Noncompliant Weld Inspection Techniques

Line 114 Non Destructive Examination Final Report

Issue Date December 5, 2013

Weld 771 cited for indications of internal undercut from 12-24

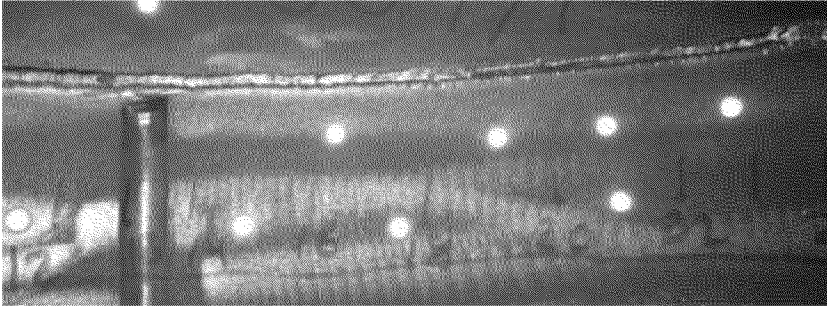
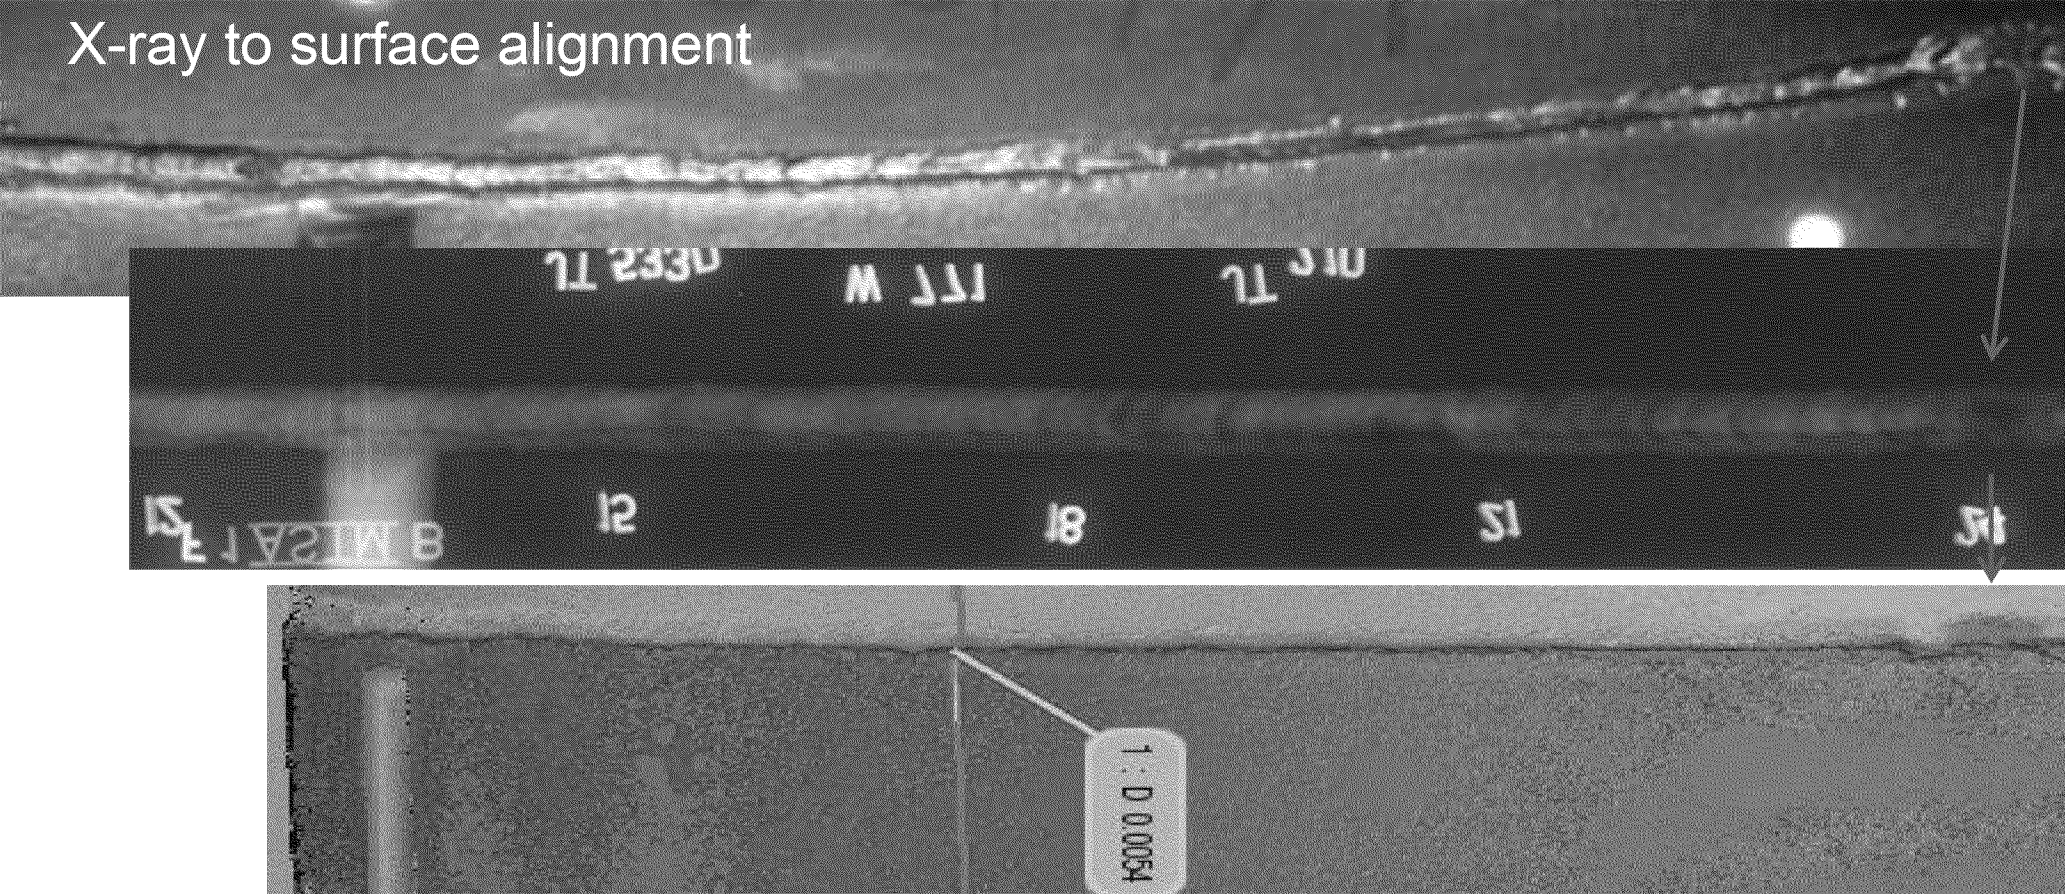
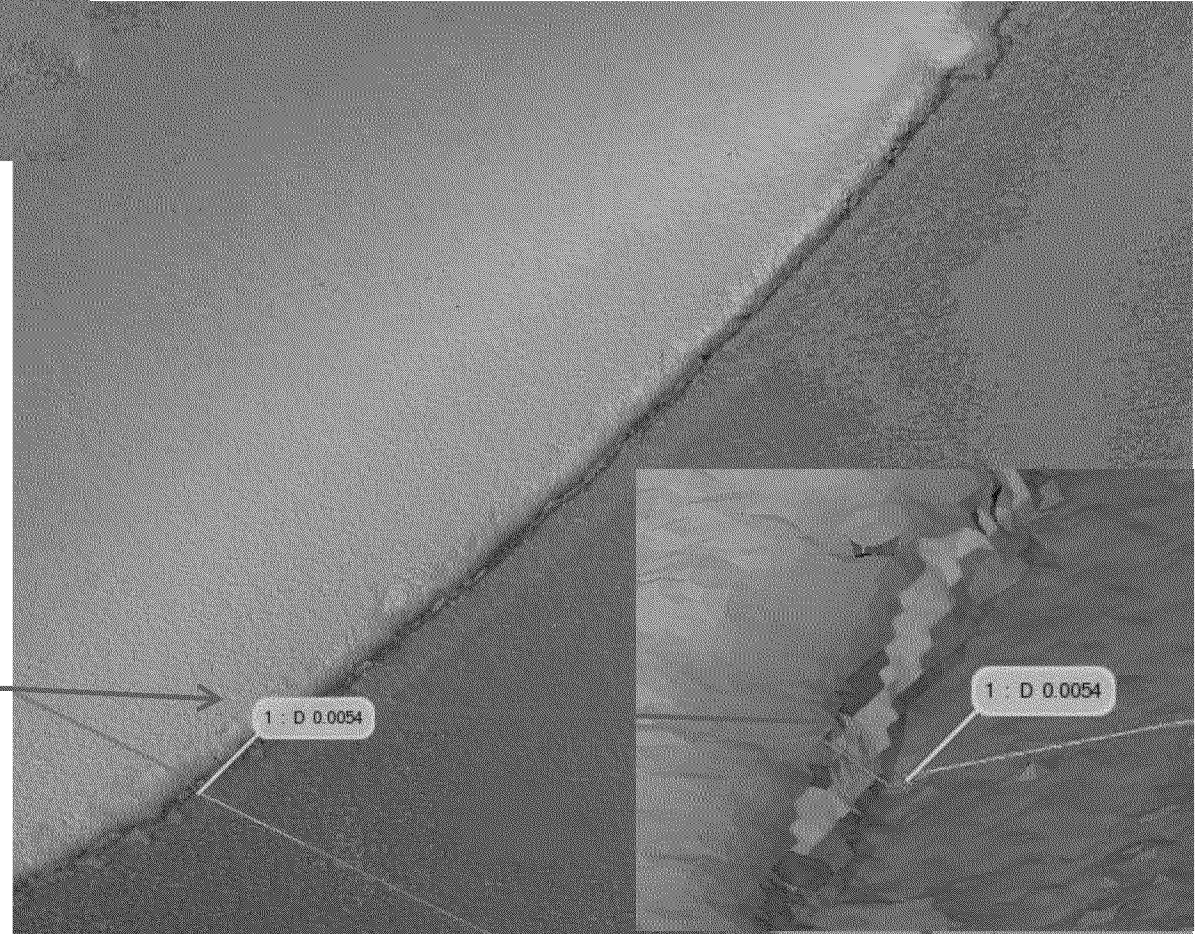
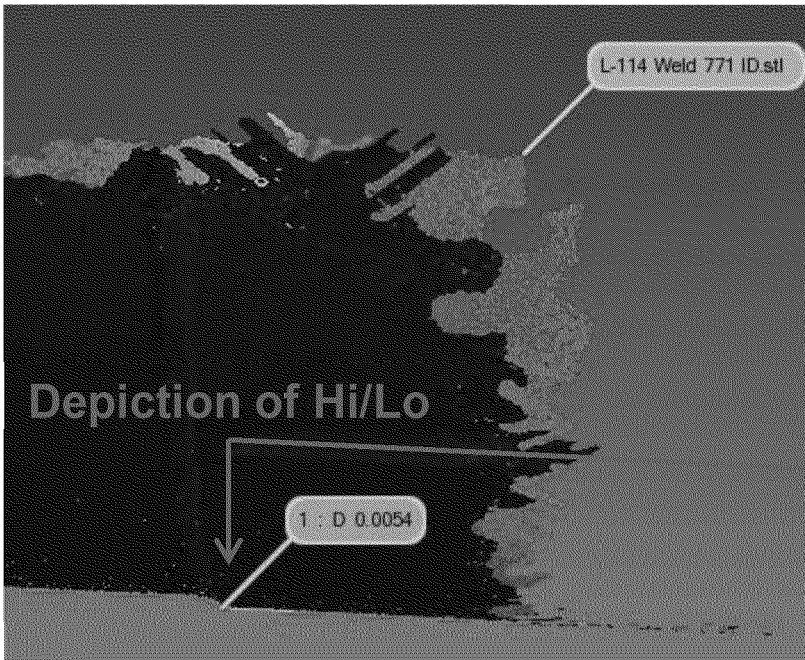
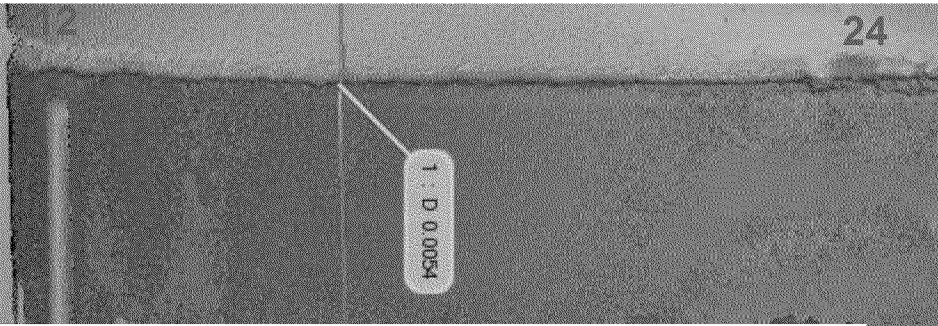
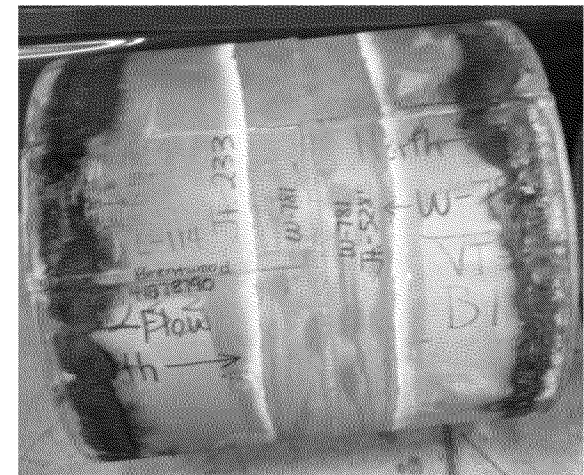
RT estimated depths of up to 0.008 inches

- Confirms indications are mostly diffraction effects on minor hi/lo condition with 0 UC
- Deepest region along length is 0.006 inches
- Weld is acceptable per API 1104

- * Confirms UC indication is diffraction/"shadowing" from high/low condition
- * Weld is acceptable per API 1104

Weld 781 cited for indications of internal undercut from 44-49

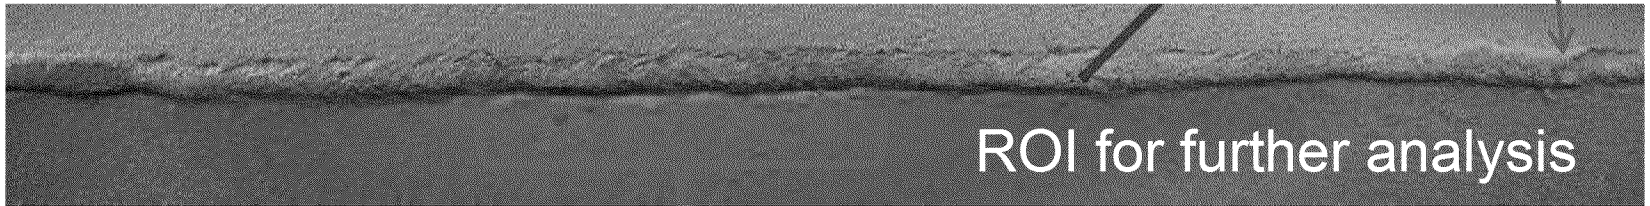
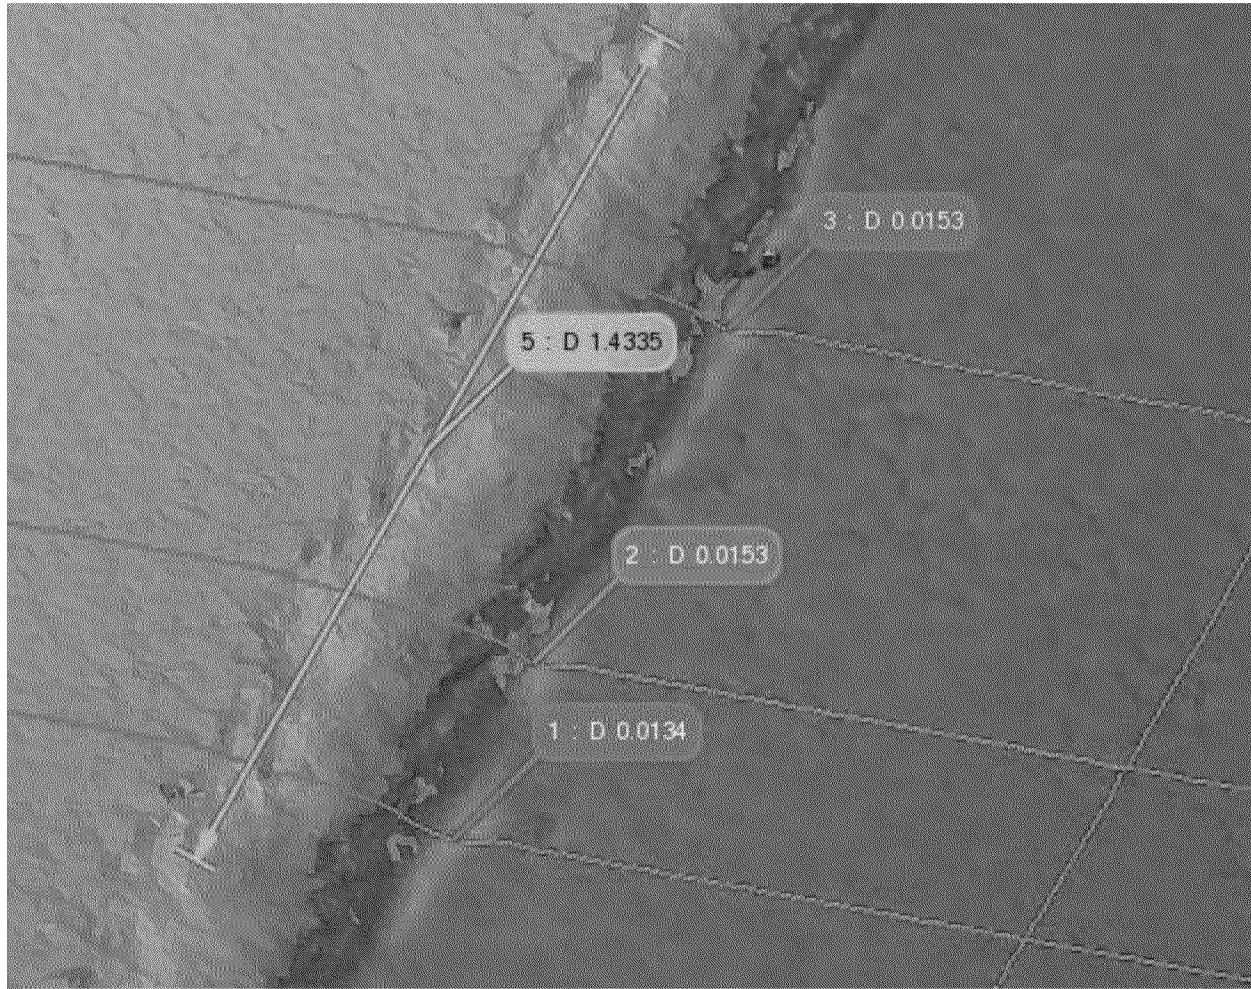
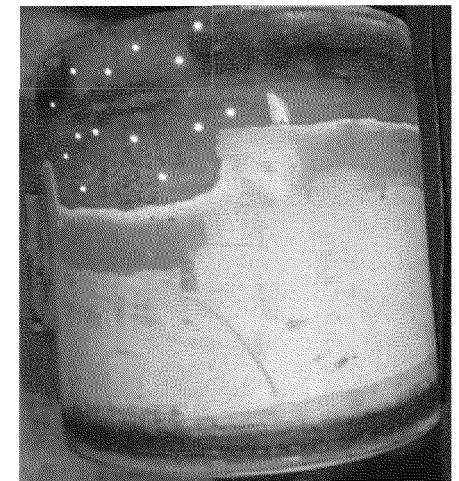
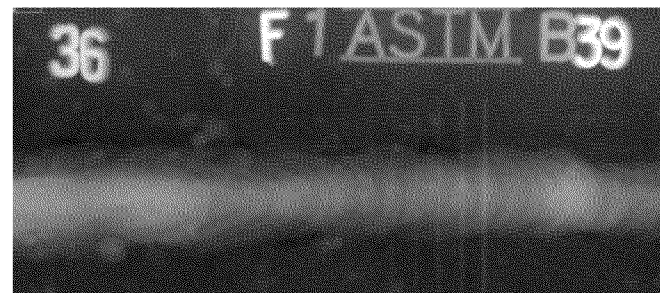
Confirms indications are mostly diffraction effects on minor hi/lo condition with 0 UC

Largest region is 1.5 long x up to 0.015 inches deep

Weld is acceptable per API 1104

- * Confirms UC indication is, in the majority, diffraction/"shadowing" from high/low condition with less than 2 inches of up to 0.015 inches deep IUC
- * Weld is acceptable per API 1104

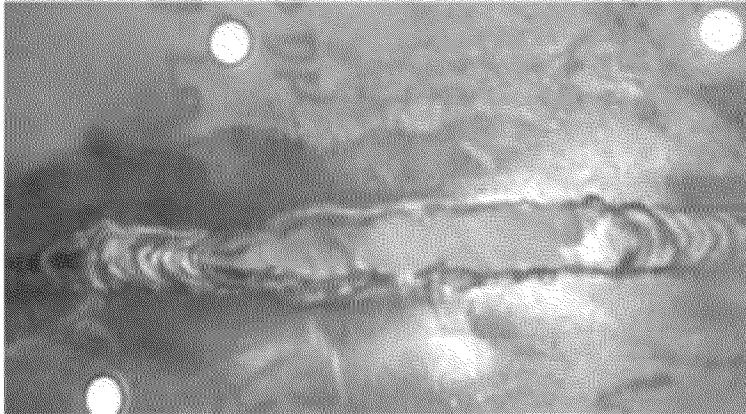
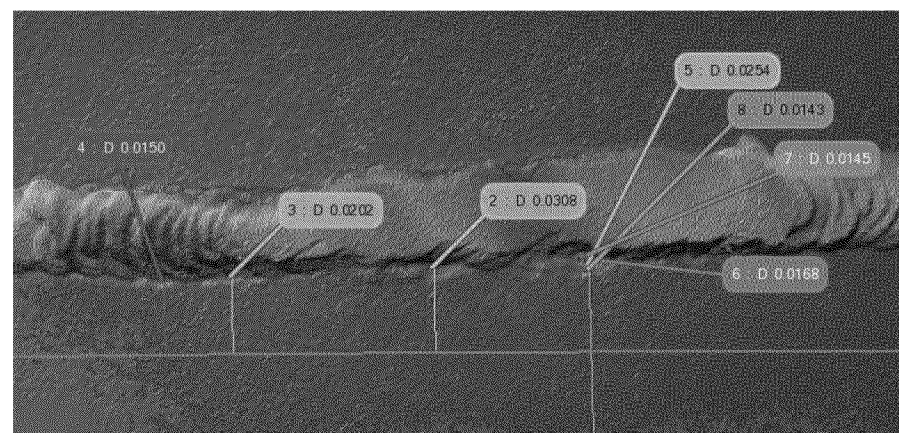
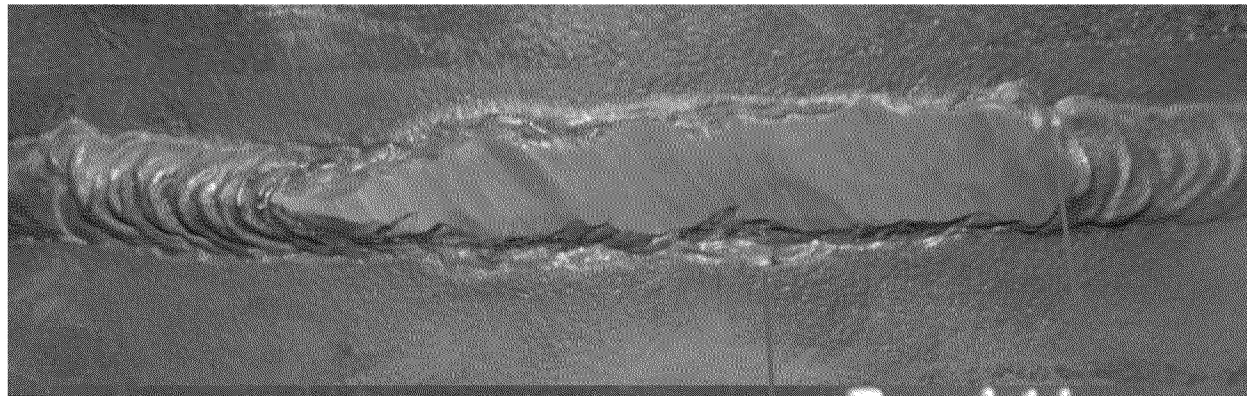
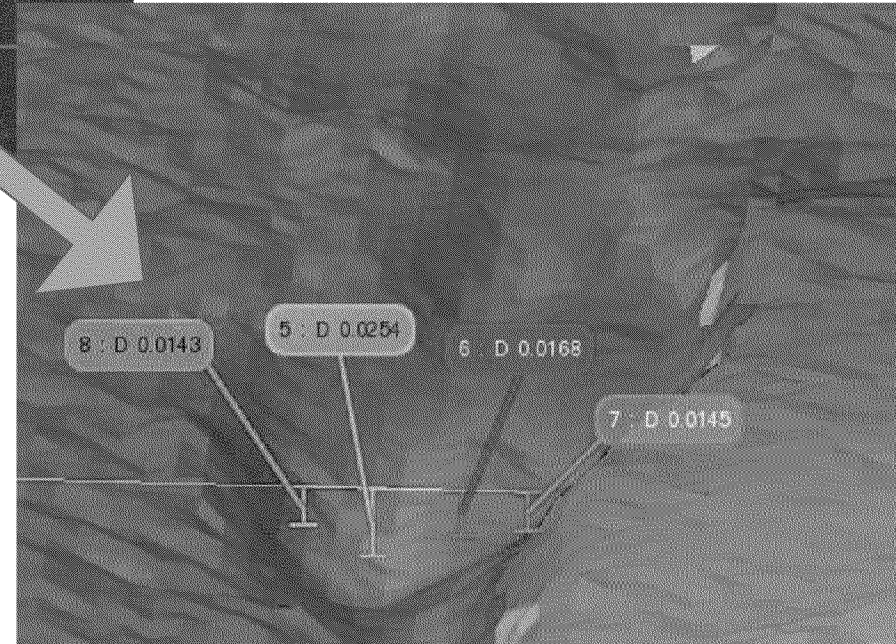
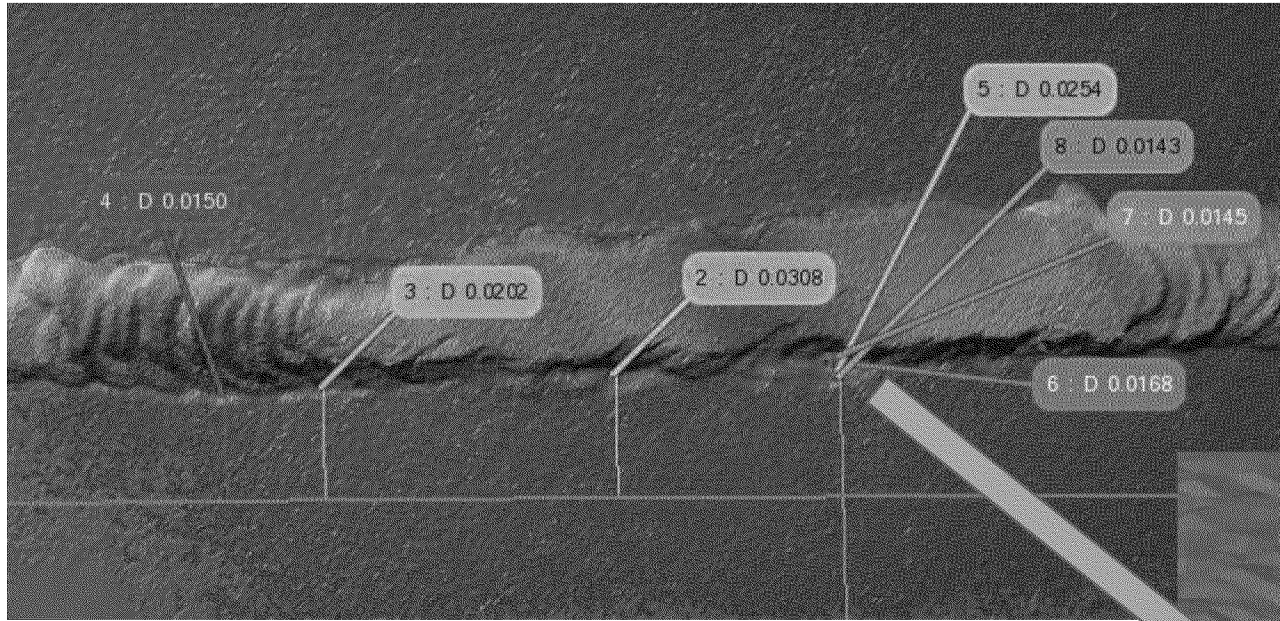
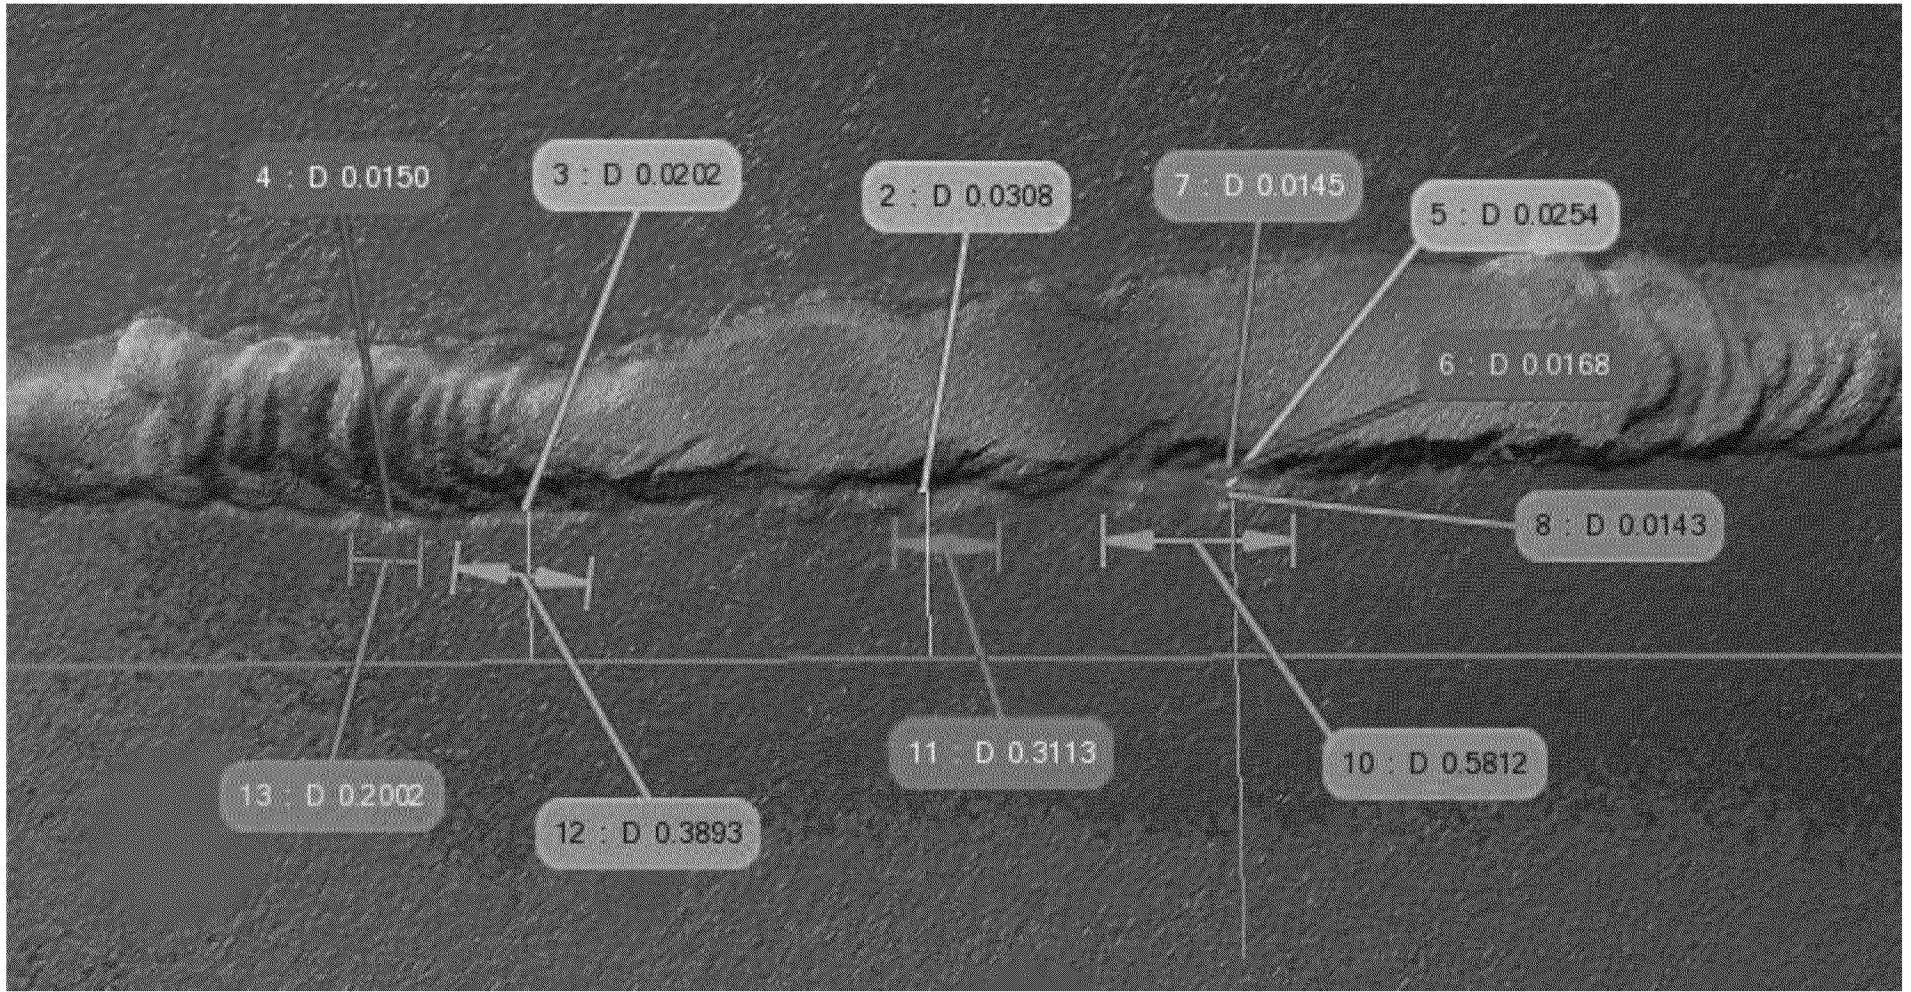
RT estimated depths of up to 0.030 inches

External undercut identified up to 0.030" deep

Sum of UC lengths < 1.5"

Weld is acceptable per API 1104
